Release Notification and Corrective Action

Name of Company: Williams Four Corners LLC	Contact: Aaron Galer
Address: Arroyo 1755 Arroyo Drive, Bloomfield, NM 87413	Telephone No.: (801) 584-6746
Facility Name: Florance Gas Com J No. 16A	Facility Type: Pipeline
Surface Owner: BLM	Mineral Owner
API No. 30-045-21790

New Mexico Oil Conservation Division approval and conditions listed below are made in accordance with OCD Rule 19.15.5.11

Remedial Assessment Work Plan

WILLIAMS FOUR CORNERS LLC	
FIGURE NUMBER 3	FLORANCE GC J 16A PROPOSED SOIL BORINGS
CBI Environmental & Infrastructure, Inc. 6380 South Fiddlers Green Circle, Suite 310 Greenwood Village, Colorado 80111

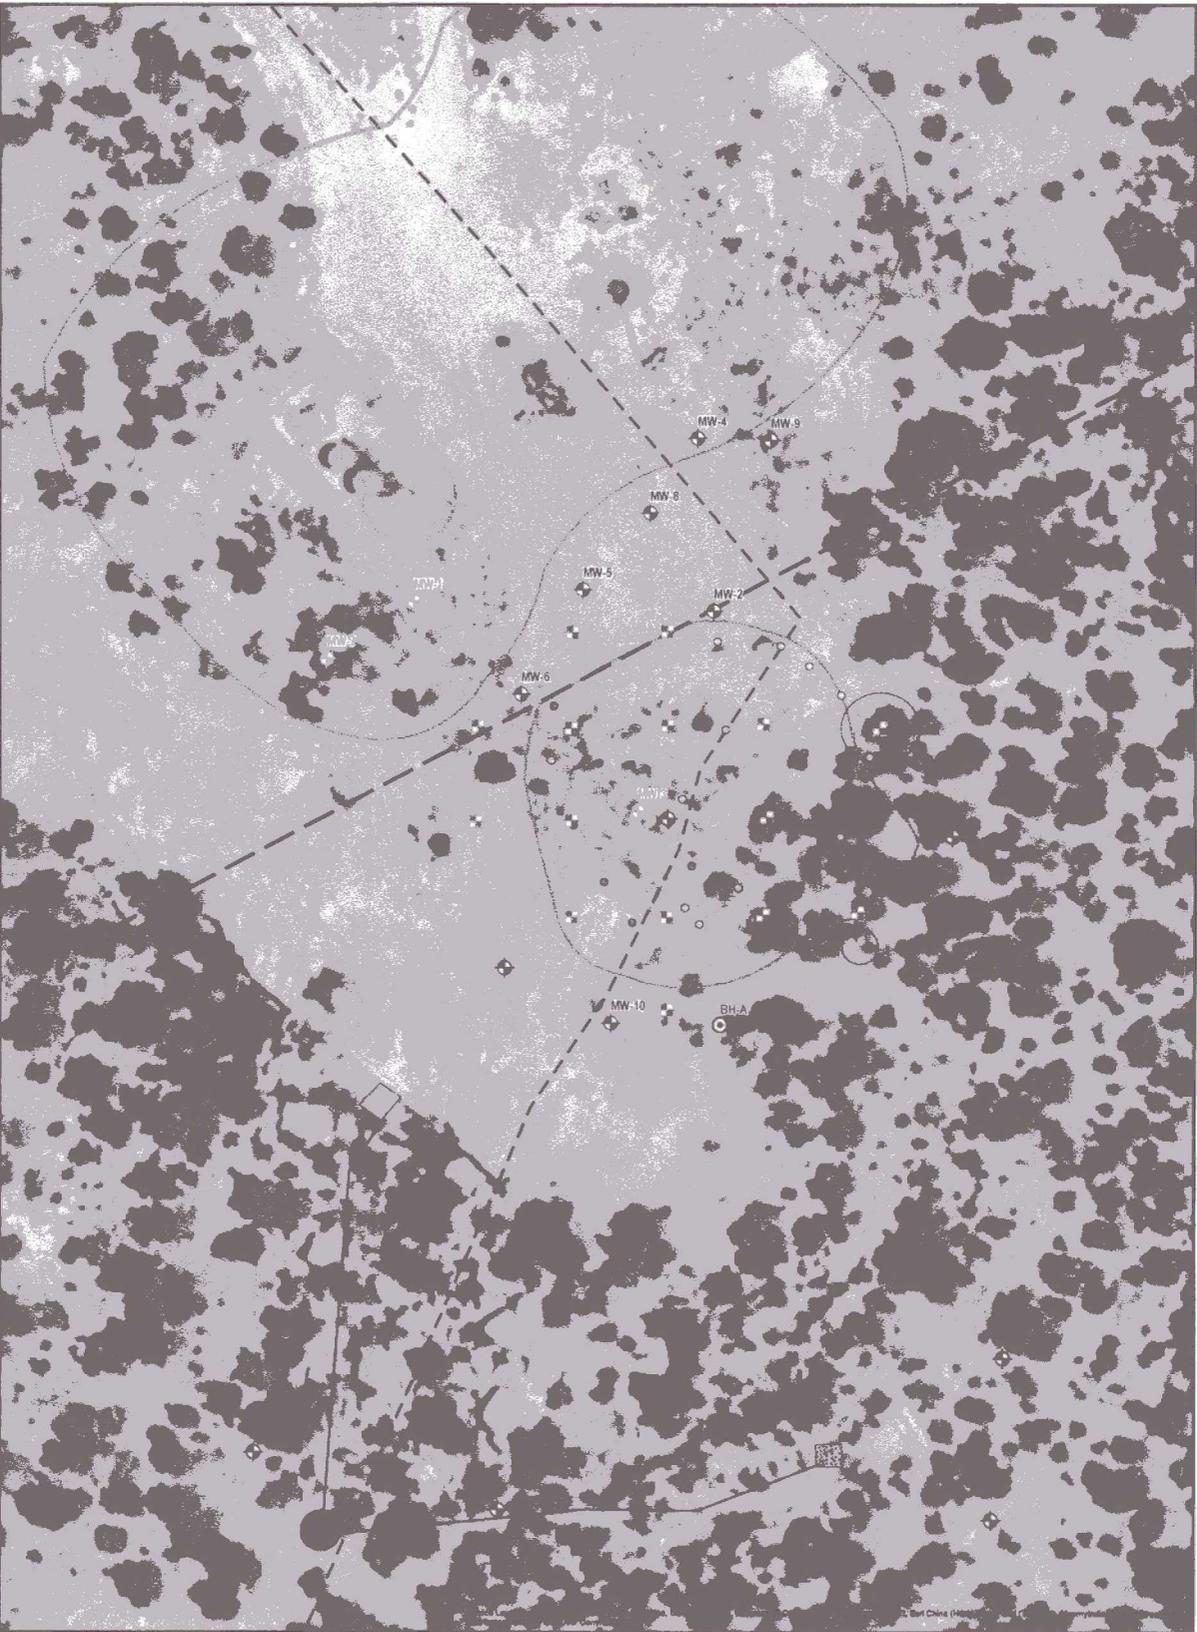
- As per Phone conversations, the OCD is requesting Williams to include an additional Borehole(BH) to the NE outside of the excavation. OCD is also requesting that Williams reposition one of the proposed SE BH or include an additional BH to be outside the excavation. (Please see attached "Figure 3" with proposed areas final positions can be discussed onsite).
- Within 30 days of completion of delineation Williams will submit to the OCD a delineation report and proposed alternative remediation plan.
- As per the October 6, 2016 Letter upon completion of MW-3R Williams will start the recovery of Light Non-Aqueous Phase Liquids (LNAPL) from MW-3R if present.
- Following the NMOCD Guidelines for Remediation's of Leaks, Spills and Releases the remediation's levels for soils at the Florance Gas Com J 16A are as follows 10 mg/kg Benzene, 50 mg/kg BTEX and 100 mg/kg TPH (DRO-GRO-MRO)
